## **NOTIFICATION 17-05-19**

Subject: Soft Engine Isolators

Affected Models: RV-12 E-LSA aircraft that received a Powerplant Kit between

**FIGURE 1:** ENGINE ISOLATOR IDENTIFICATION

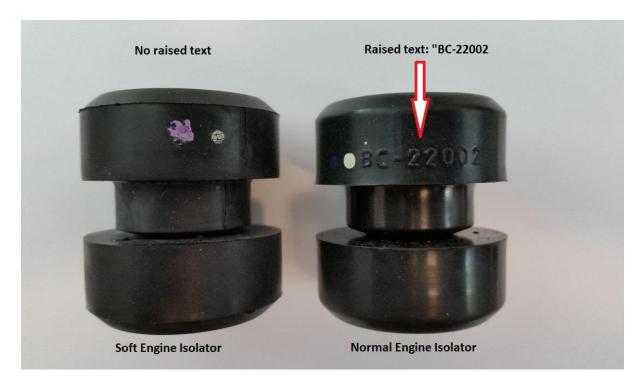
If the isolator has the text "BC-22002" as shown in the figure below on at least one half of the isolator the correct isolators are installed. Make a logbook entry noting compliance with this notification and place a copy of this notification in the back of the Maintenance Manual.

If the isolator has no text as shown in the figure below contact Van's Aircraft for a replacement engine isolator set. Replace the isolators using KAI Section 46 as reference. Make a logbook entry noting compliance with this notification and place a copy of this notification in the back of the Maintenance Manual.

Replacement parts if applicable Qty 4... EA 22002-15 (isolator) Qty 4... MS24665-283 (cotter pin)
